NACIMIENTO WATER PROJECT
 ADDENDUM NO. 03
 for
 PIPELINE SOUTH
 CONTRACT NO. 300187.08-05
 SPECIFICATION No. 05

ADDENDUM

DATE: July 24, 2007
PROJECT: Pipeline South
ADDENDUM NO.: 3
BID OPENING: August 2, 2007

Drawing No.
G1P-C278

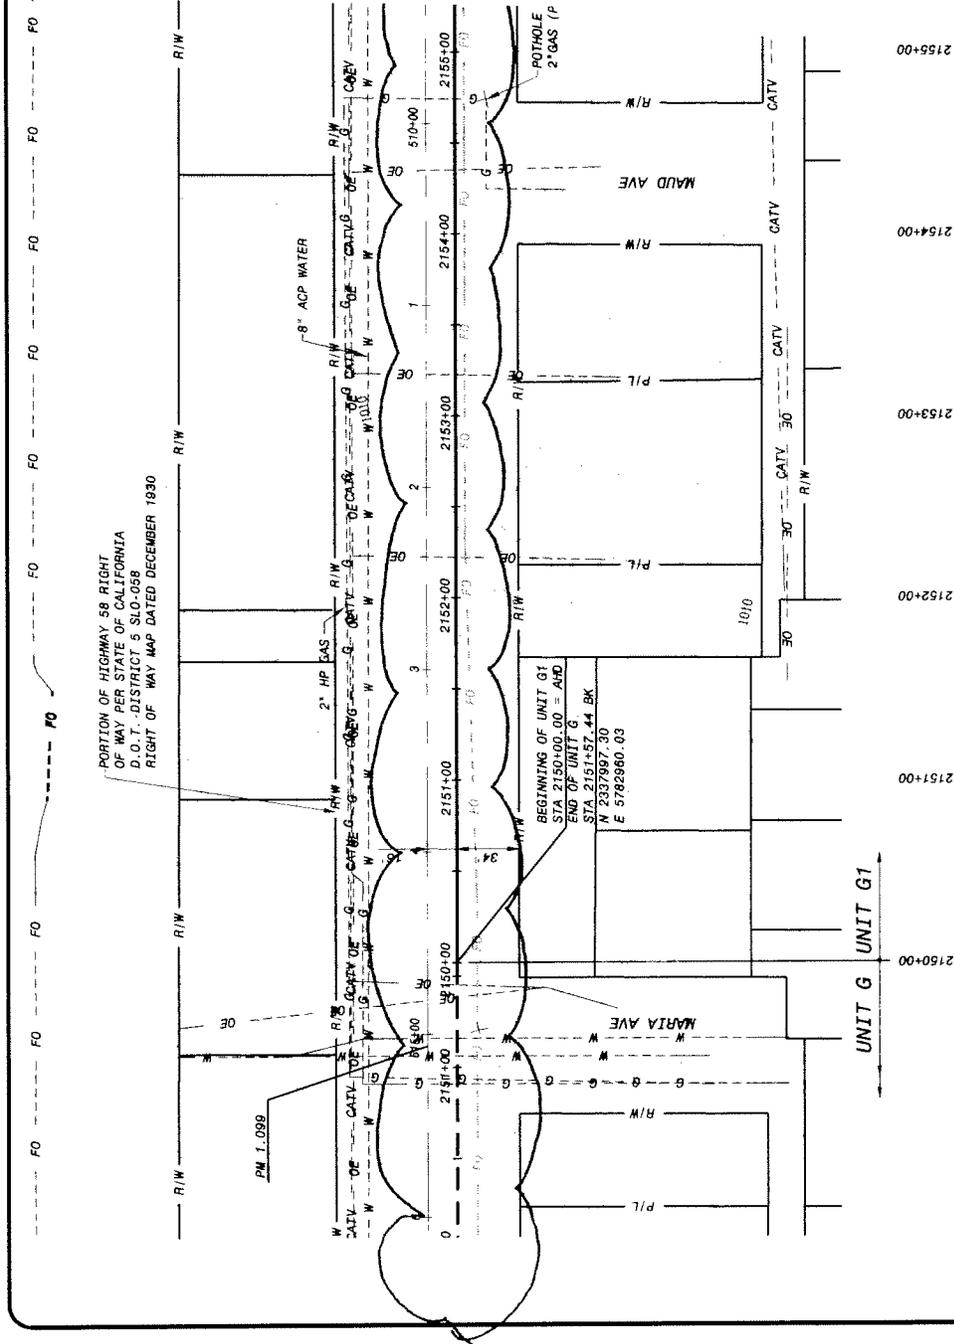
6. Drawing GP-C278, Sheet 70 of 155, added (4) 1-1/2” fiber optic conduits as shown on attached Sketches 300187.08.05-SK17 and –SK18.
7. Drawing GP-C278, Sheet 70 of 155, revise the fitting at Sta 2146+20.91 from an 18” elbow to an 18” tee with a blind flange installed on the branch that points northeast on El Camino Real.

Added Fiber Optic Conduits

Drawing No.
T11-C301

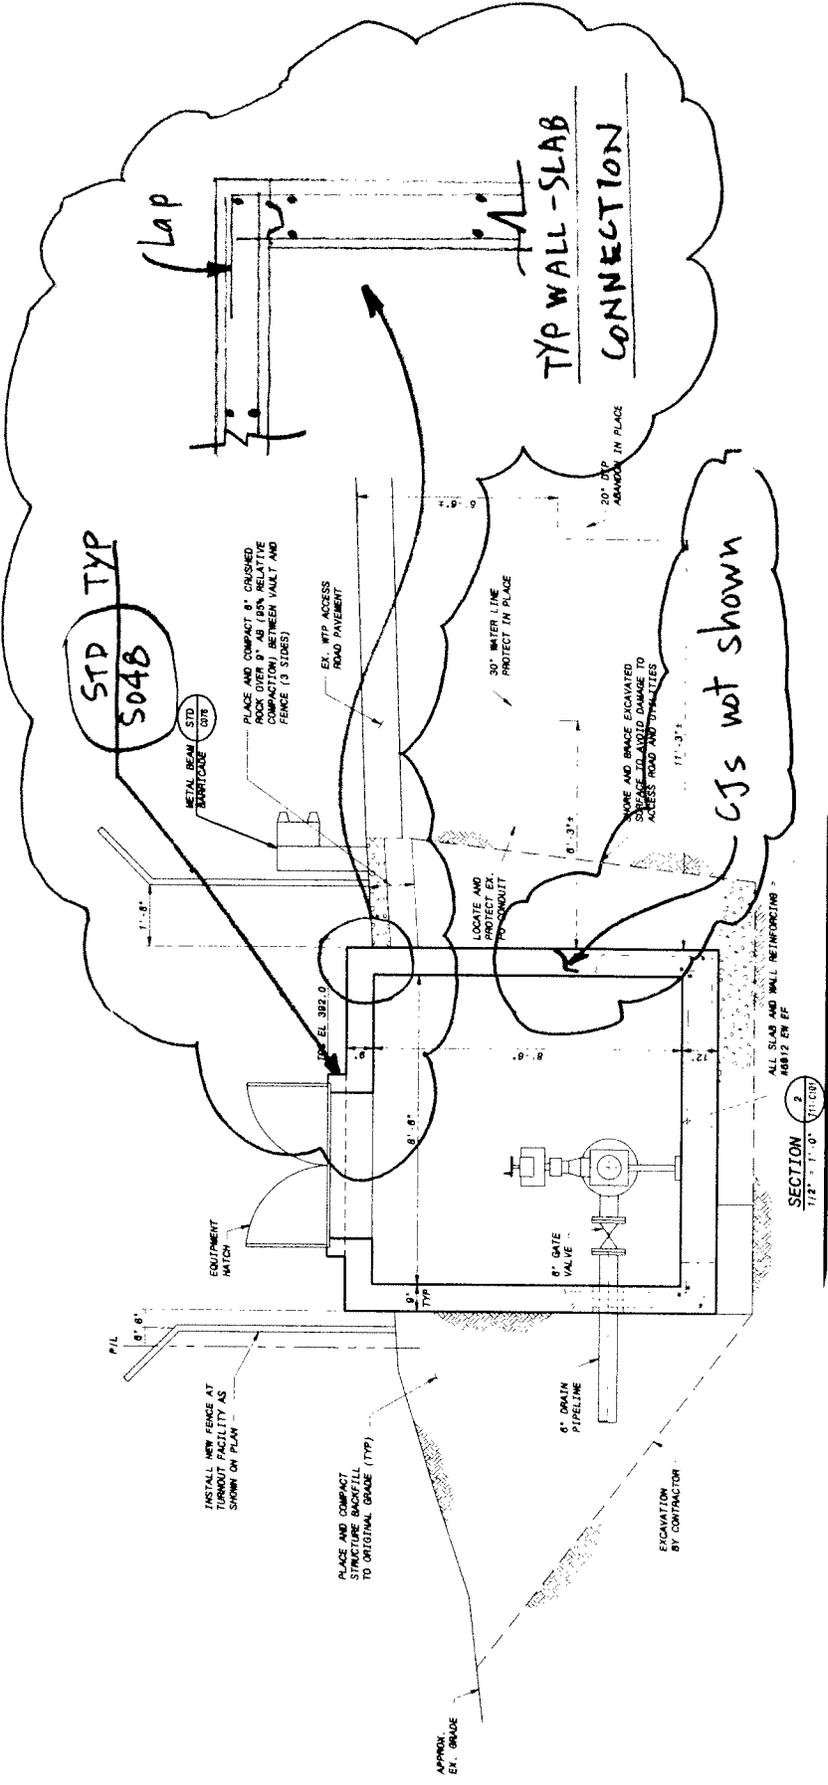
Misc. Revisions
